SERVICE INFORMATION

STANDARD AND TRIUMPH VEHICLES

No. SPORTS/4/A

T.R. III INFORMATION

No.	SPORTS/3/P	ACCELERATOR PEDAL MAXIMUM LIMIT STOP FOR LEFT HAND DRIVE CARS	Date	FEBRUARY 1956
------------	------------	--	-------------	---------------

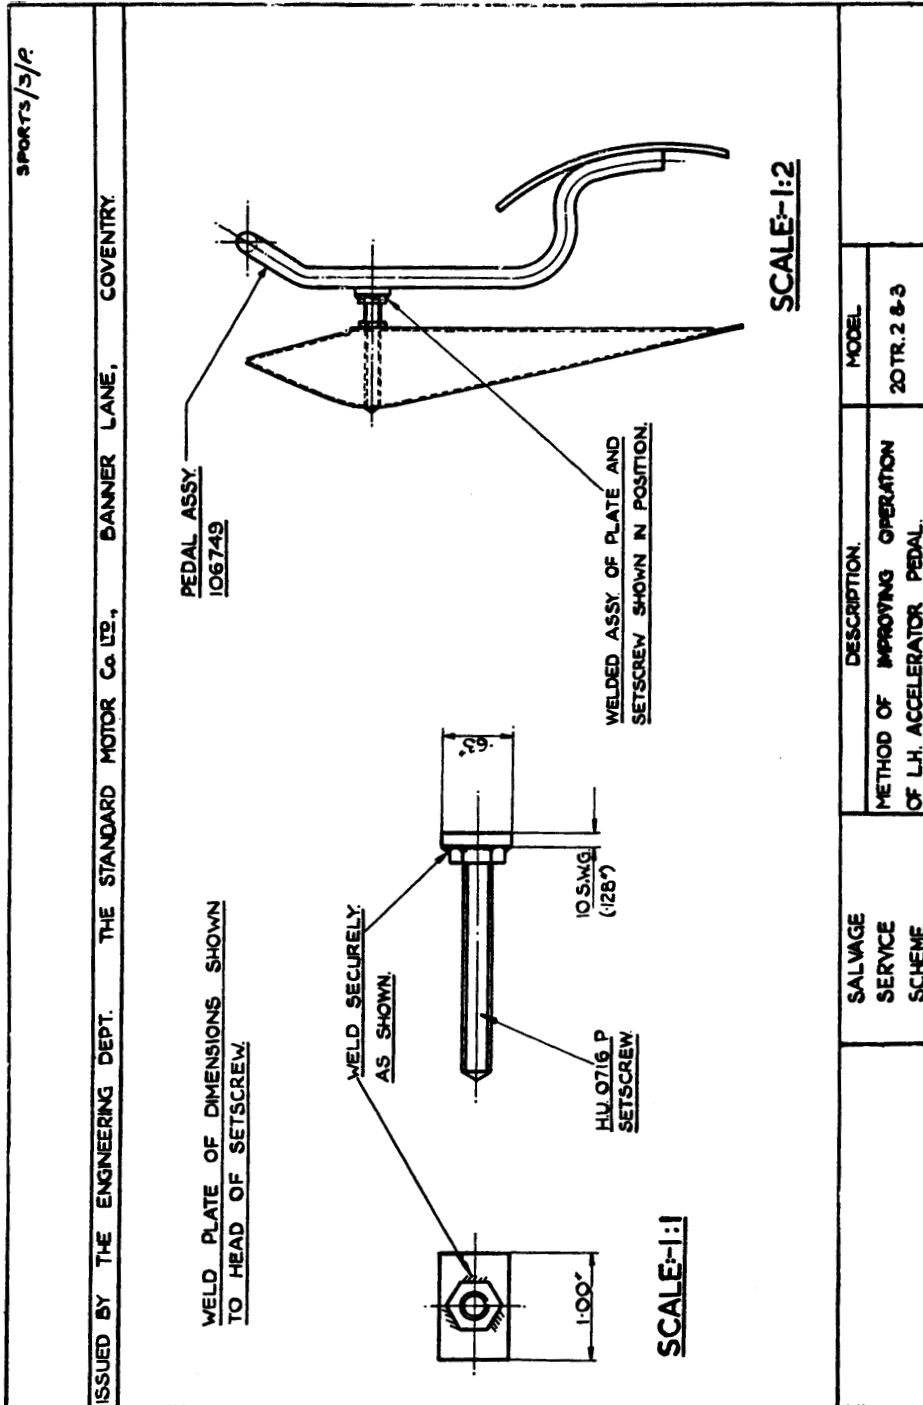
It has been decided to modify the limit stop for L.H. Drive T.R.III's in normal manufacture and to supply information on a method which can be applied to cars already in service.

With the original design, if it is necessary to reset the accelerator pedal after a car leaves the Factory, resulting misalignment of the pedal with the stop can allow the former to pass the limit stop, thereby interfering with its free return when released.

To simplify the method of fitting a suitable stop on cars already in service, the illustration gives details for incorporating a stop plate on the limit stop screw, which is already fitted in the dash panel.

The fully positive pedal limit stop will be of special interest to owners who use L.H. drive cars for rally and racing events, but should also be fitted to other L.H.D. cars where necessary.

The method being used in normal manufacture, incorporates a stop plate attached to the accelerator pedal. All future replacements of this assembly supplied by our Spares Division will have this plate fitted.

Care should be taken that the stop plate is adjusted after fitting so that its 1" side is horizontally positioned.

No.	SPORTS/2/S	EXHAUST PIPE VIBRATION	Date	MAY 1956
-----	------------	------------------------	------	----------

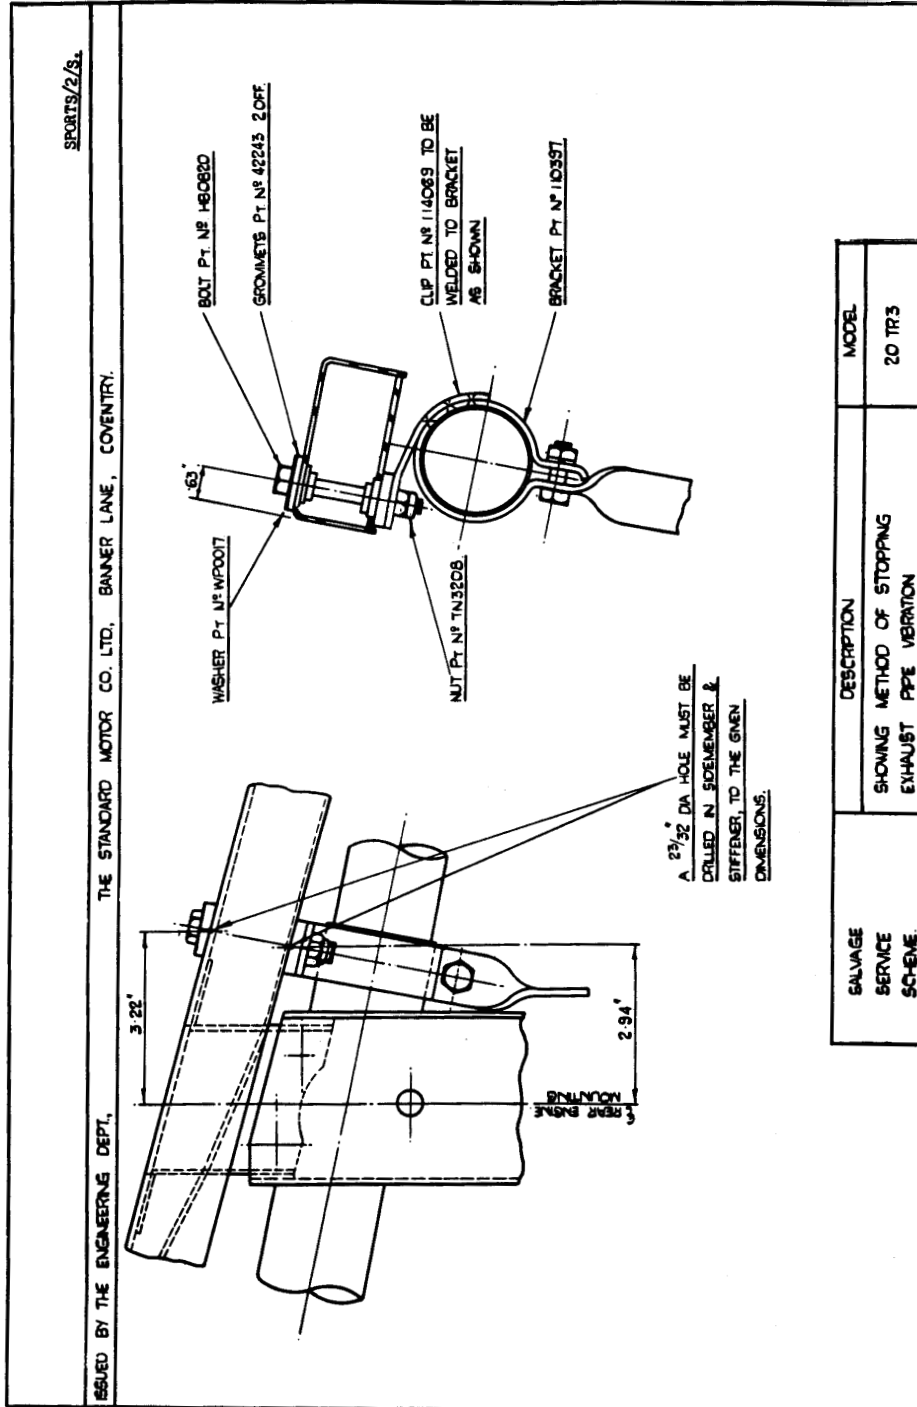
If an exhaust pipe vibration, which is not infrequently thought to be an engine vibration, is experienced at 2000-2500 r.p.m. the forward exhaust pipe mounting can be modified as shown in the illustration. The following parts are affected by this change:

1. Exhaust pipe support bracket, Part No. 110397, has been replaced by support bracket assembly, Part No. 114074.

2.	<u>Parts deleted.</u>	<u>Part No.</u>
	Flexible mounting strip.	105291
	Clamp plate.	105290
	Setscrew.	HU.0809
	Washer.	WP.0034
	Nut.	TN.3208
3.	<u>New Parts.</u>	<u>Part No.</u>
	Grommet (2 off)	42243
	Bolt (1 off)	HB.0820
	Washer (1 off)	WP.0017
	Nut (1 off)	TN.3208

It will be seen from the parts affected that the flexible mounting strip supporting the original bracket, Part.No. 110397, in a vertical plane has been deleted.

The original mounting used on the L.H. section of the cruciform, which supports the front pipe bracket, remains unchanged. The new mounting, which is an identical assembly to the latter, is used to support the R.H.S.of the bracket and is attached to the R.H. section of the cruciform.
